**Disposition of Surplus
Highly Enriched Uranium
Final Environmental
Impact Statement**

**Volume II
Comment Analysis and Response Document**

June 1996

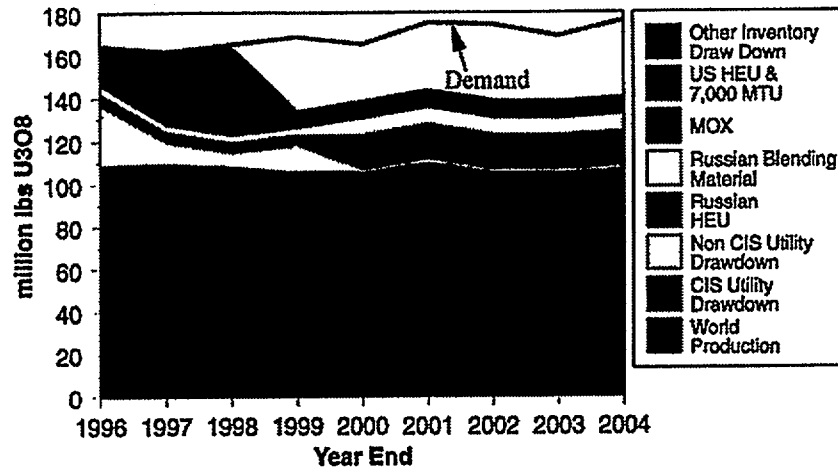
This shows the drawdown of 5 MTU @ 70%, 45 MTU @ 37.5%, and 120 MTU @ 45% of US HEU blending to 4.0% (not including the blending material) and 7,000 MTU of natural uranium

This material represents the following UO8:

5 MTU @ 70% and 45 MTU @ 37.5%	lbs UO8
120 MTU @ 45%	12,800,000
7,000 MTU Natural	33,900,000
TOTAL	18,200,000
	64,900,000

The drawdown of this uranium is limited to 4,000,000 lbs/year starting in 1998 pursuant to the USEC Privatization Bill (\$755). HEU blending capacity of 10 MTU of HEU per year is also a limiting factor. At 10 MTU of HEU per year it would take 17 years to blend the HEU mentioned above. If the 64,900,000 lbs UO8 is delivered over 17 years this would represent 3,800,000 UO8/yr.
